RE: ERC0222 Generator Technical Performance Standards

Tasmanian Networks Pty Ltd (TasNetworks) is pleased to provide our response to the *Consultation Paper – National Electricity Amendment (Generator Technical Performance Standards) Rule 2017* which was published by the AEMC on 19 September 2017.

Figure WFPS1.4 – Minimum Reactive Power Capability of Controllable WFPS

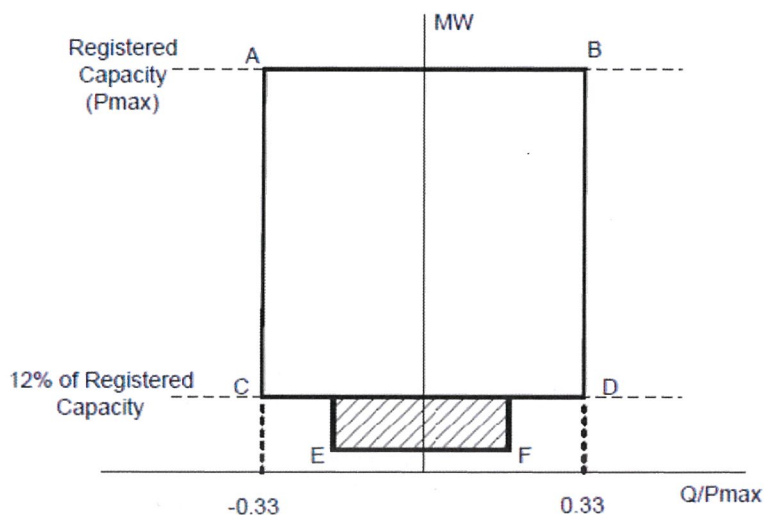
While the intent is fully supported, the minimum access standard being proposed requires additional consideration. In TasNetworks view, linking the minimum required reactive power capability with fault level is a questionable added complication. The fact that the minimum access standard may climb to be equal to the automatic access standard at the strongest locations in the network (where the required additional reactive power may be minimal) suggests an almost perverse outcome.

TasNetworks is in favour of a simple metric that is less onerous than the automatic access standard, but guarantees the provision of some reactive capability at the connection point to assist with network voltage control. Such an approach would also be consistent with a number of overseas Grid Codes.

As a suggestion, TasNetworks would recommend consideration of a figure similar to that applied by EirGrid² for controllable wind farms as shown below:
